**SUNDRY NOTICES AND REPORTS ON WELLS**  
*Do not use this form for proposals to drill or to re-enter an abandoned well. Use form 3160-3 (APD) for such proposals.*

8. Well Name and No.  
CEDAR CANYON 21 FEDERAL 1

9. API Well No.  
30-015-28354-00-S1

OXY USA Inc. - Current  
 Cedar Canyon 21 Federal #1  
 API No. 30-015-28354

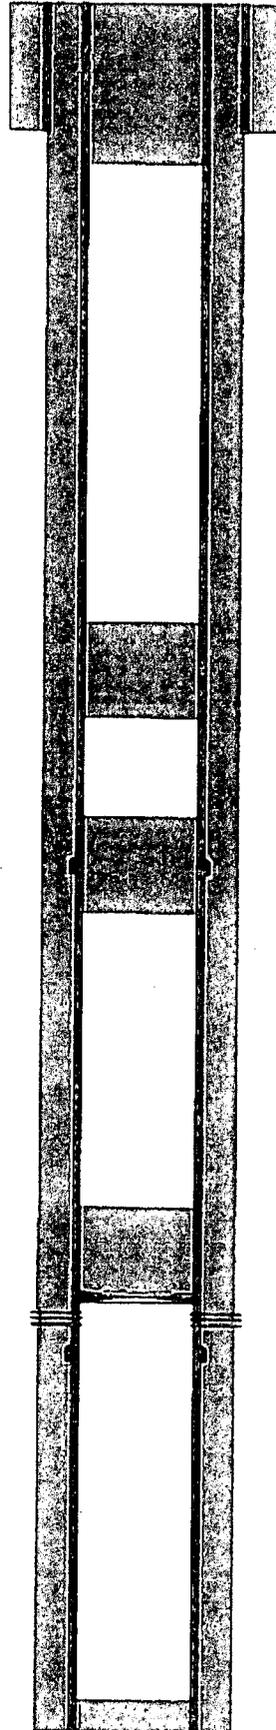
| Est. Tops   | Actual |
|-------------|--------|
| B/salt 3030 | 2743   |
| Del 3108    | 2947   |
| BS 6842     | 6649   |

- RIH & set CIBP @ 5162', M&P 25sx cmt to 4915'
  - M&P 25sx cmt @ 3616-3366' WOC-Tag
  - M&P 25sx cmt @ ~~2950-2695~~ 3660 - 2695' WOC-Tag
  - M&P 55sx cmt @ 630' to Surface
- 10# MLF between plugs-Above ground steel tanks will be utilized
